NORTHERN WOLVES
AIR CONDITIONING

Project: **Sunrise Rye Brook - Independent Living / Assisted Living**

Mechanical drawings dated: 07.15.2026 (GMP set)

Mechanical Value Engineering Proposals

M2108 AL unit plans - TX-A bath exhaust to exterior, SG-1 / RG-2 DOAS grilles

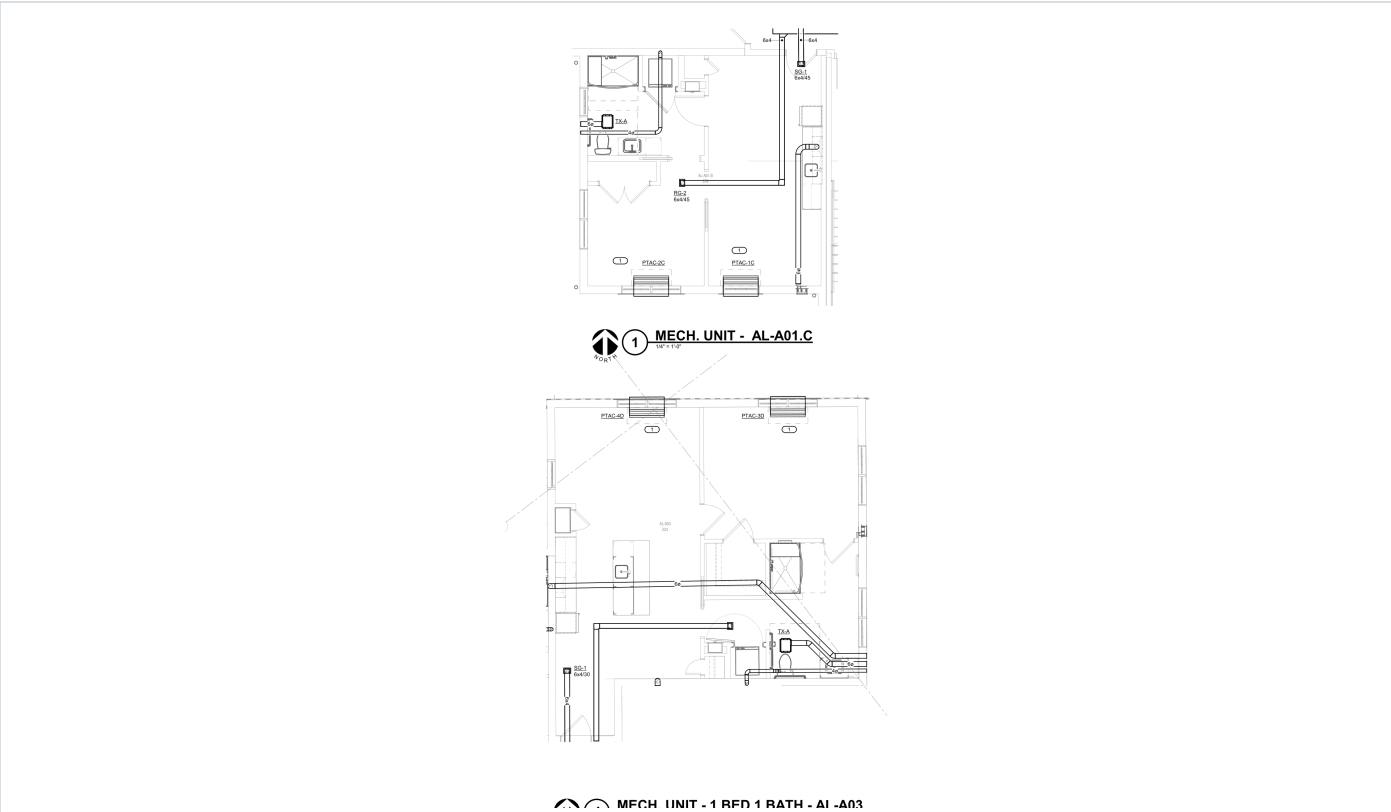
VE-08 Apartment bath exhaust to the DOAS energy recovery

- Each apartment bath has its own exhaust fan TX-A (75 CFM) ducted out the exterior wall
- DOAS return is taken from corridors and a few rooms; some AL unit types show a DOAS return grille RG-2, the floor plans connect the return trunk to only a few (to be clarified)

- Duct apartment bath exhaust to the DOAS exhaust trunk in the corridor (as on Sunrise of Northport); the DOAS energy wheel recovers the exhaust heat
- Delete the individual TX-A fans, wall caps and their electrical circuits; delete RG-2 in the units

Approvals / coordination: IMEG; DOAS exhaust airflow check.

M5000 - BMS-controlled hydronic terminals eliminated by VE-01 to VE-05

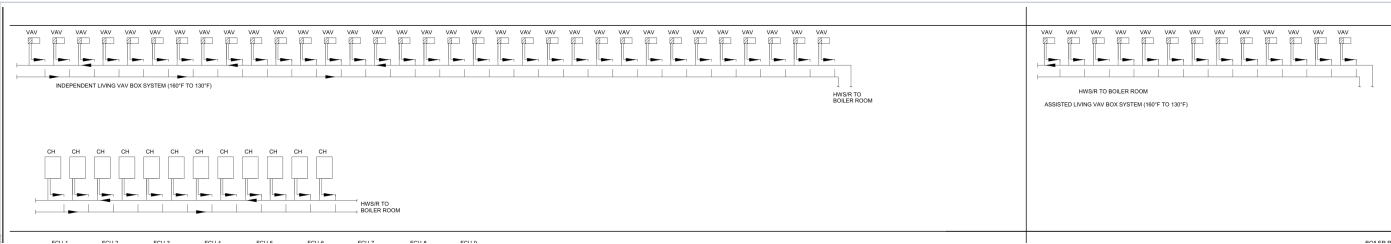
VE-09 Controls: standalone equipment controls in lieu of BMS

- Full BMS by the BMS contractor for boilers, pumps, heat exchangers, glycol, snow melt, VAV reheat, FCUs, cabinet heaters, rooftop units and DOAS

- With VE-01 to VE-06 the hydronic sequences (about 120 to 150 points) are gone
- Rooftop units and DOAS on their factory controls with network cards for future monitoring; heaters, mini-splits and PTACs on standalone thermostats (as on other Sunrise communities)

Approvals / coordination: Sunrise approval of the controls standard.
